Access Compliance Report

Public Rights-of-Way

(Curb Ramps)

Intersection ID: 54219	Main Street: SANDY_ROCK_PL	Cross Street: NORTH_REA_PARK_LN	Location: NW
ADA ID: 11F515BFFBD1	Ramp Type: Perp	Initial Pass/Fail: Pass	Overall Compliance: No
		Severity Score: 5.25

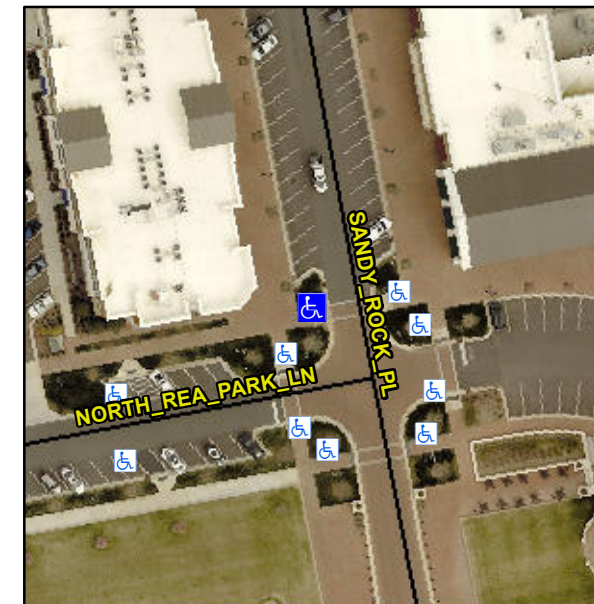
R304.5.3, R304.5.4

Compliance	Description	Data	Compliance	Description	Data
N/A	Ramp Length (in)	84.0	Yes	Ramp Slope (%)	6.6
Yes	Ramp Width (in)	96.0	No	Ramp XSlope (%)	4.1
Yes	Flare Type L	Curbed_NoWalkSurface	Yes	Flare Type RT	N/A
Yes	Flare Slope LT (%)	N/A	N/A	Flare Slope RT (%)	N/A
N/A	Flare Traversable LT?	No	N/A	Flare Traversable RT?	No
Yes	Landing Length (in)	90.0	Yes	DWS Provided?	Yes
Yes	Landing Width (in)	96.0	Yes	DWS Contrast?	Yes
Yes	Landing Slope (%)	0.2	Yes	DWS Length (in)	24.0
Yes	Landing X Slope (%)	0.7	Yes	DWS Full Width?	Yes
N/A	Landing Curb? (Y/N)	No	Yes	DWS Offset (in)	0.0
N/A	Shared Landing?	No			
Yes	Gutter Ponding?	No	No	Gutter Slope (%)	6.8
Yes	Gutter Lip Ht (in)	0.0	Yes	Gutter X Slope (%)	0.1
N/A	Painted X Walk1?	Yes	N/A	Painted X Walk2?	N/A
	X Walk 1 Direction	To E		X Walk 2 Direction	N/A
N/A	X Walk 1 Width (in)	79.0	N/A	X Walk 2 Width (in)	N/A
	X Walk 1 Slope (%)	3.6		X Walk 2 Slope (%)	N/A
	X Walk 1 X Slope (%)	2.3		X Walk 2 X Slope (%)	N/A

**Remove & Replace Entire Ramp.
Remove & Replace Gutter.**
